Project	IEEE 802.16 Broadband Wireless Access Working Group < http://ieee802.org/16 >	
Title	Text Clarification and Clean-up for the MAC Header	
Date Submitted	2005-05-04	
Source(s)	Hang Zhang, Mo-Han Fong, Peiying Zhu, Wen Tong Nortel Networks	mhfong@nortelnetworks.com
	Sean Cai, Mary Chion ZTE San Diego	scai@ztesandiego.com
	Yongseok Jin, Bin-Chul Ihm, Jin Young Chun, Ki-seon Ryu LG Electronics. Inc.	jayjay@lge.com
	Jung-je Son, Hyunjeong Kang Samsung Electronics	jungje.son@samsung.com
	Lei Wang Cygnus Communications Inc.	lwang@cygnuscom.com
	Rainer Ullmann Wavesat	rullmann@wavesat.com
	Vladimir Yanover, Tal Kaitz Alvarion	vladimir.yanover@alvarion.com
	Yerang Hur, Bong Ho Kim, Dae Joong Kim POSDATA Co. Ltd.	yehur@posdata-usa.com
	Yigal Eliaspur Intel	yigal.eliaspur@intel.com

Re:	IEEE P802.16e/D7-2005
Abstract	This contribution provides text clarification and clean-up regarding the MAC header
Purpose	Review and Adopt the suggested changes into P802.16e/D7
Notice	This document has been prepared to assist IEEE 802.16. It is offered as a basis for discussion and is not binding on the contributing individual(s) or organization(s). The material in this document is subject to change i

Figure 19a—MAC signaling header type I format

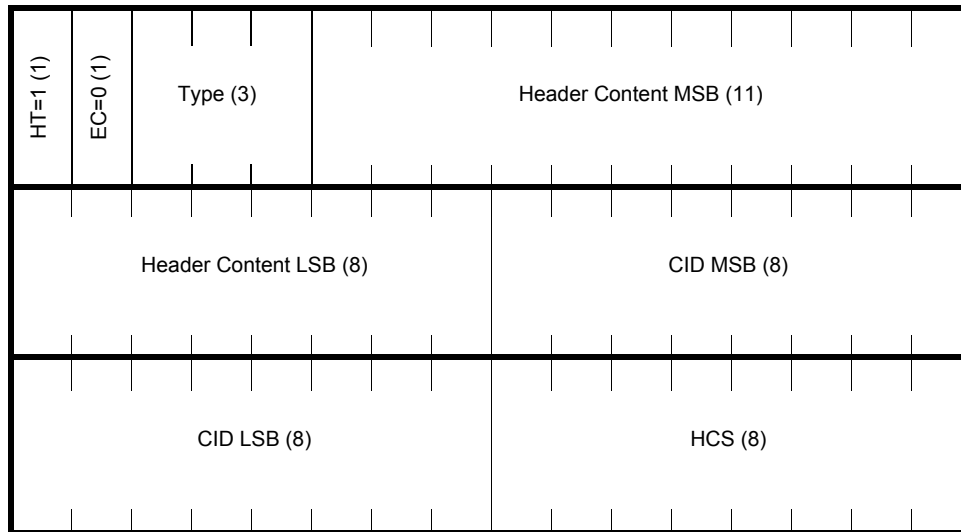
[Insert the following figure]

Figure 20c— CQICH **a**Allocation **B**andwidth request

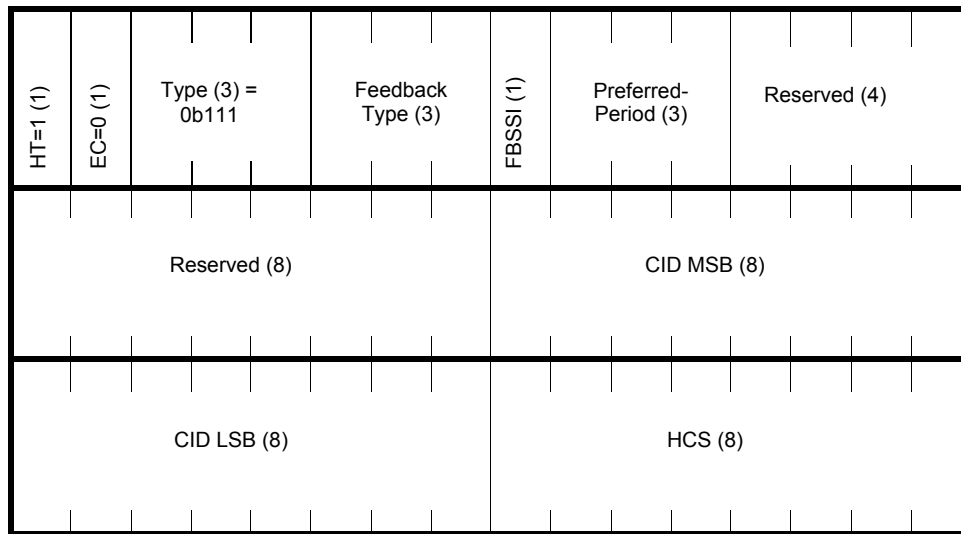
[Replace Figure 20c with the following drawing]

Figure 20d—PHY channel report header

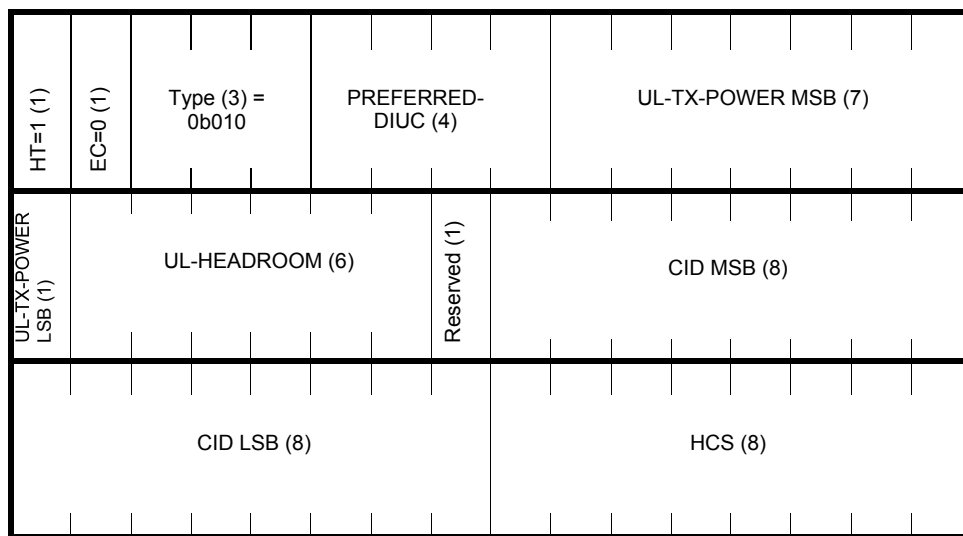
[Replace Figure 20d drawing with the following drawing, to ensure consistency in all headers' drawing format]

Figure 20e—Bandwidth request and uplink sleep control header

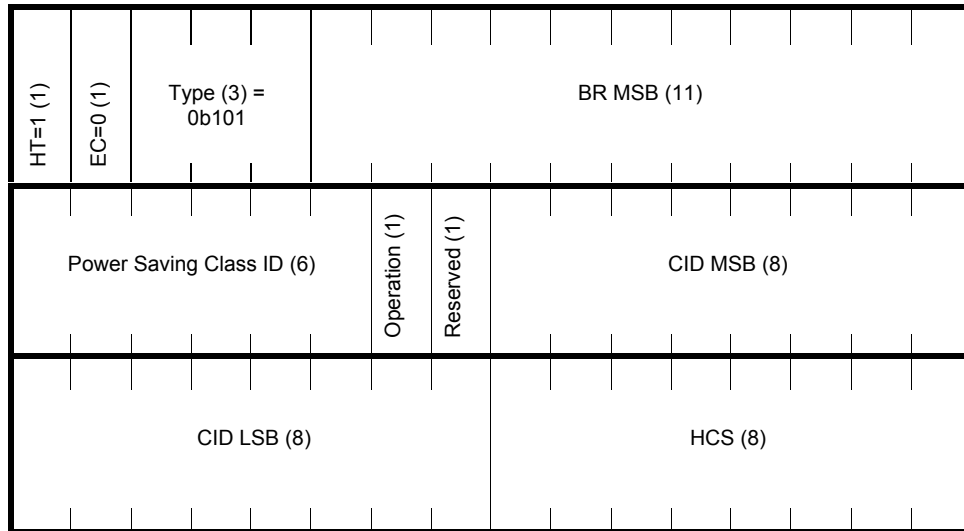
[Replace Table 7e by a new Figure and Table below, so as to be consistent with other header description]

Figure 24a20f—SN report header format

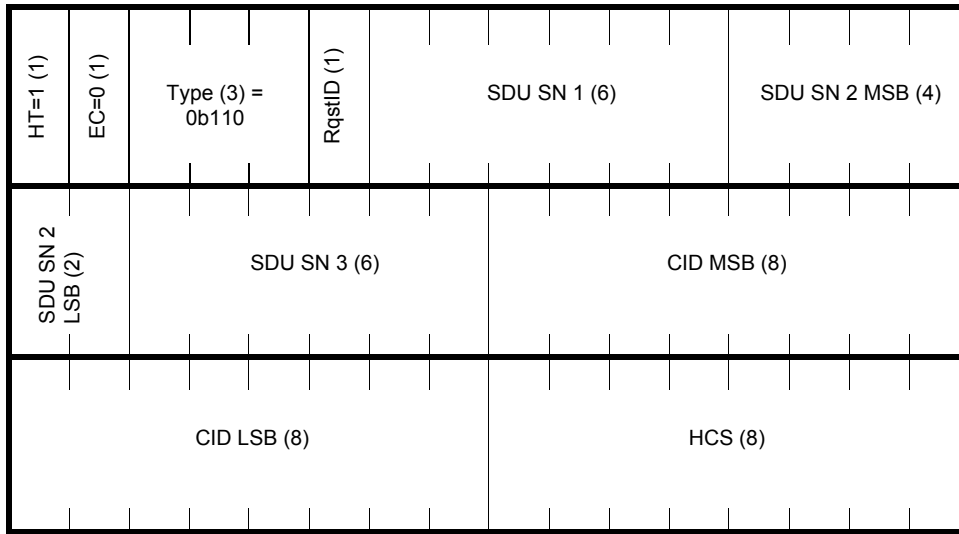
[Replace Figure 21a drawing with the following drawing to ensure consistency in headers' drawing format.]

Figure 20g— MAC signaling header type II format

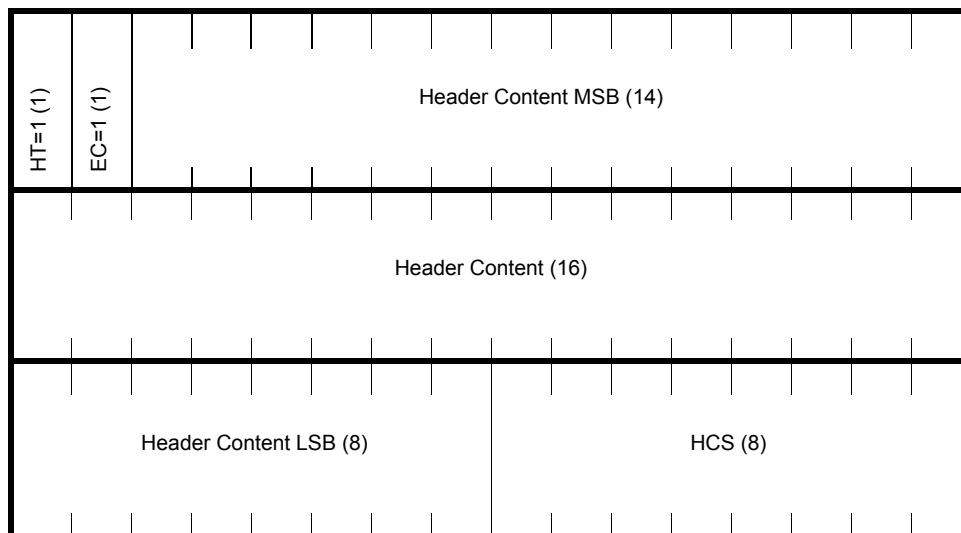
[Insert a new subclause 6.3.2.1.2.2, 6.3.2.1.2.2.1, 6.3.2.1.2.2.1.1]

Figure 20-bh — Feedback header with CID field

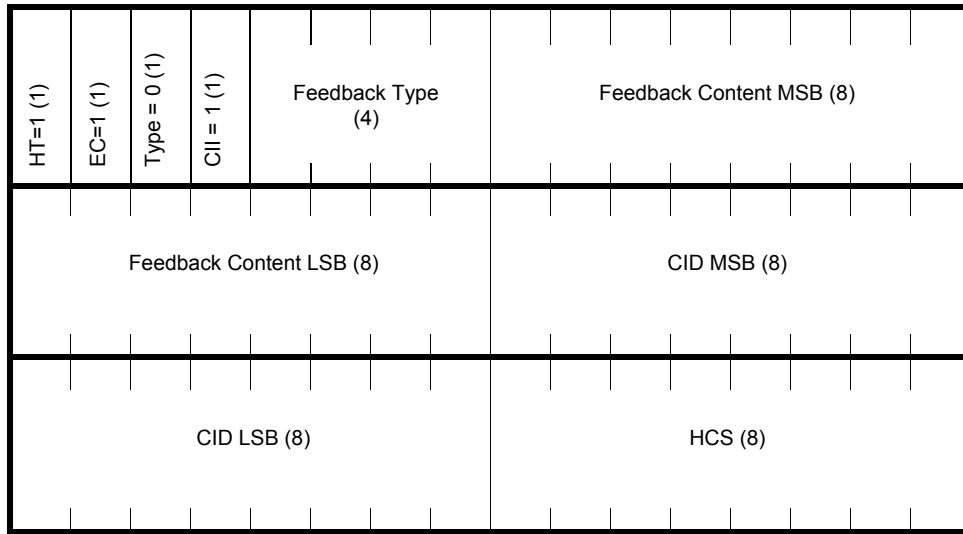
[Replace drawing in Figure 20b in p802.16e/D7 with the following drawing to ensure consistency]

Figure 20-ej — Feedback header without CID field

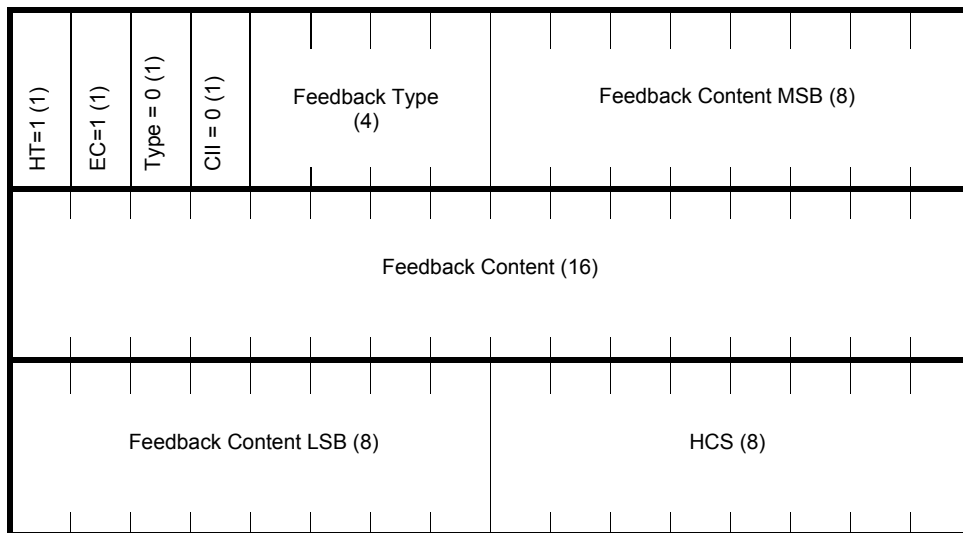
[Replace drawing in Figure 20c in p802.16e/D7 with the following drawing to ensure consistency]

Figure 20ej — MIMO Channel Feedback header with CID field

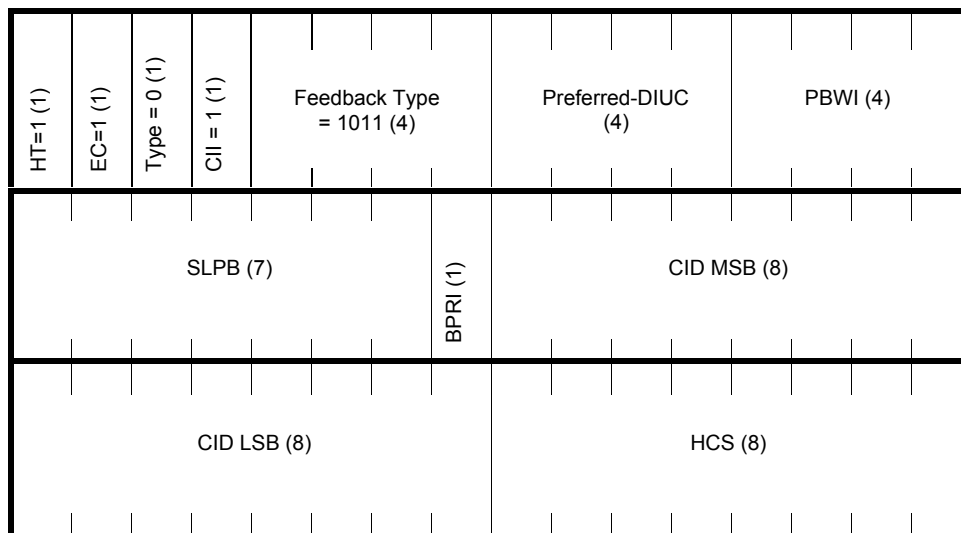
[Replace drawing in Figure 20e on page 28 in p802.16e/D7 with the following drawing]

Figure 20fk — MIMO Channel Feedback header without CID field

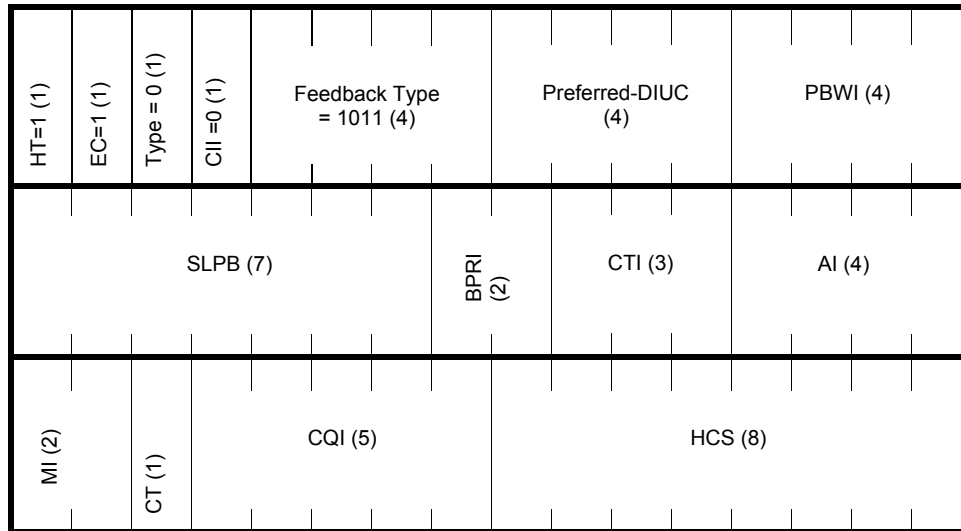
[Replace drawing in Figure 20f on page 28 in p802.16e/D7 with the following drawing]
